Landscape Mitigation Plan

Contract no. KL/2014/03

Kai Tak Development – Stage 3 Infrastructure Works for
Developments at the Southern Part of the Former Runway

Contract No. KL/2014/03 - Kai Tak Development - Stage 3 Infrastructure Works for
Developments at the Southern Part of the Former Runway
Submission of Landscape Mitigation Plan

Figure B2 - Tree Protection Plan

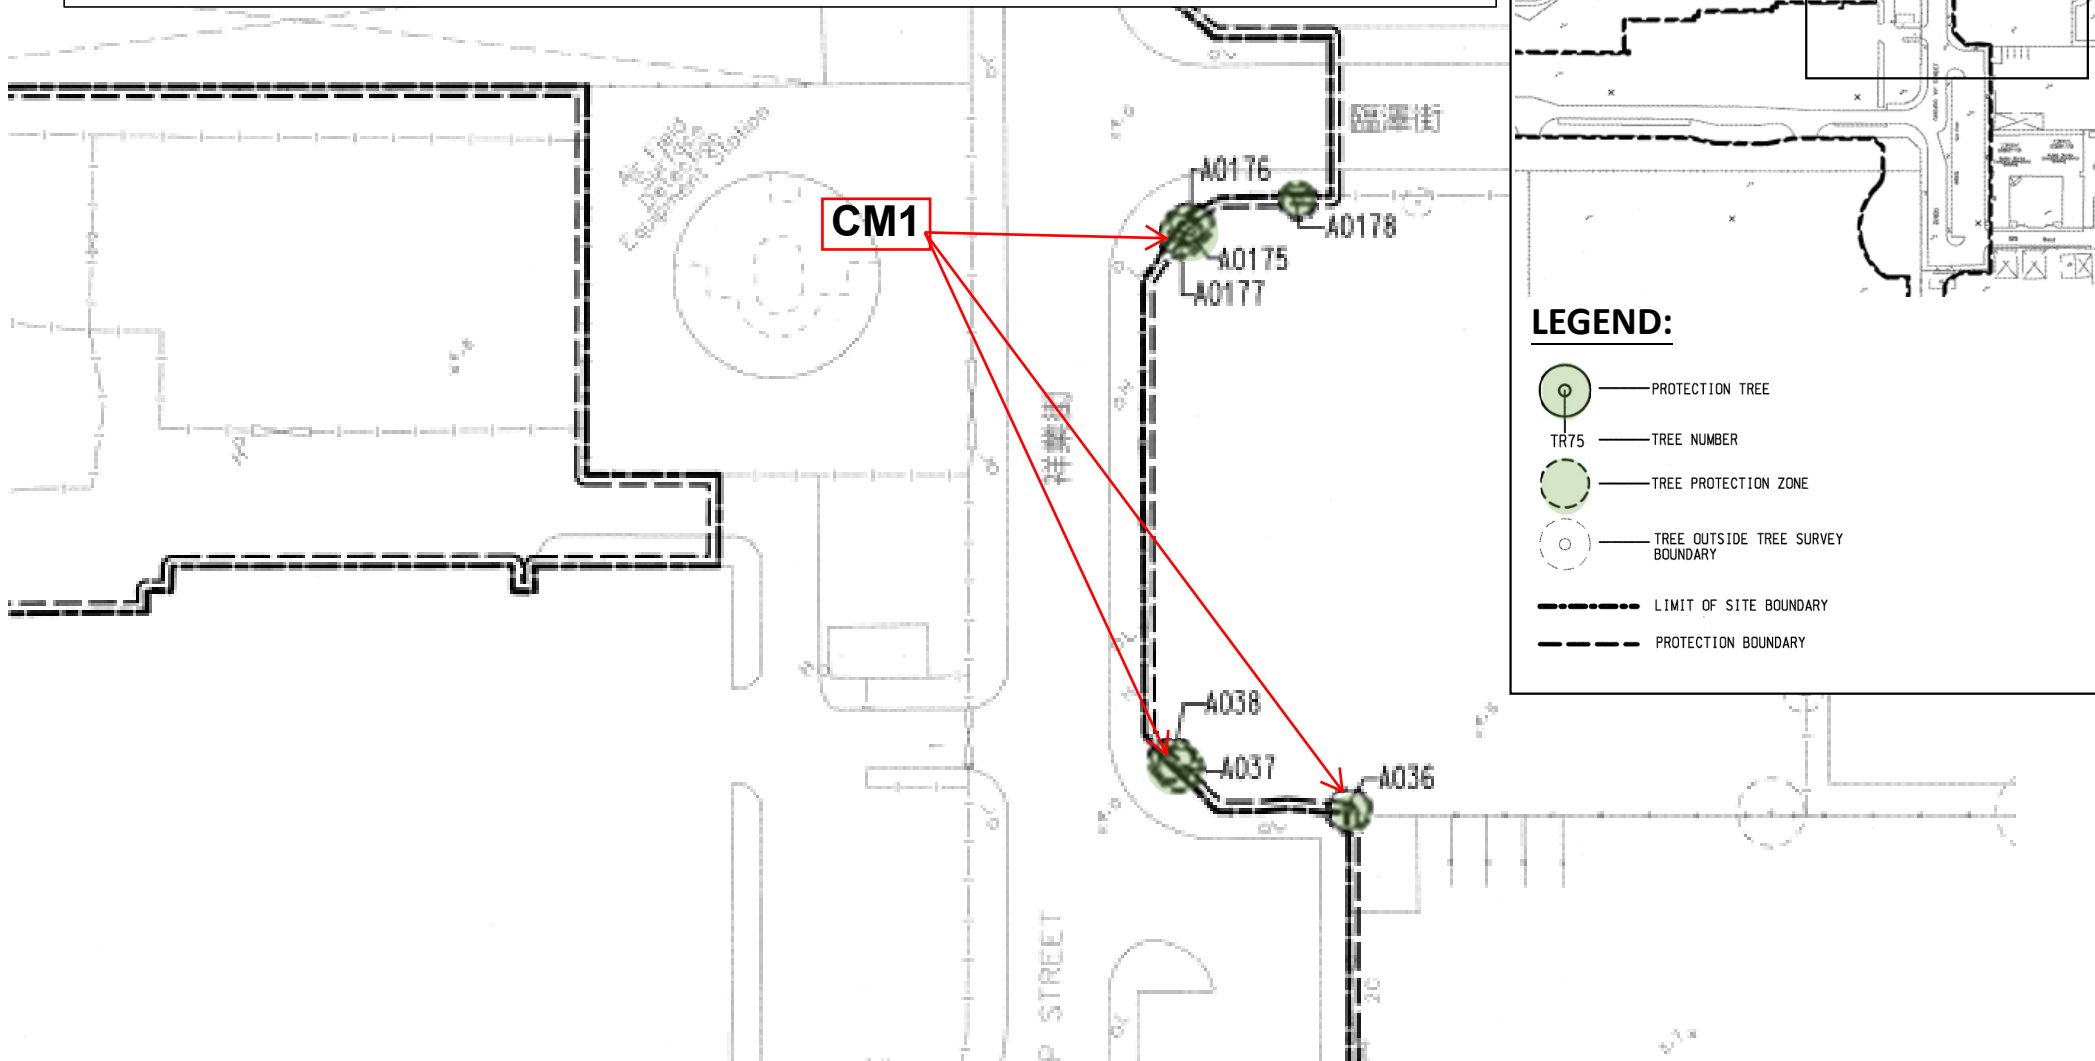
6.	Tree protection plan is missing.	Please find the blow up of tree protection plan as shown in Appendix B Figures B1 to B2.
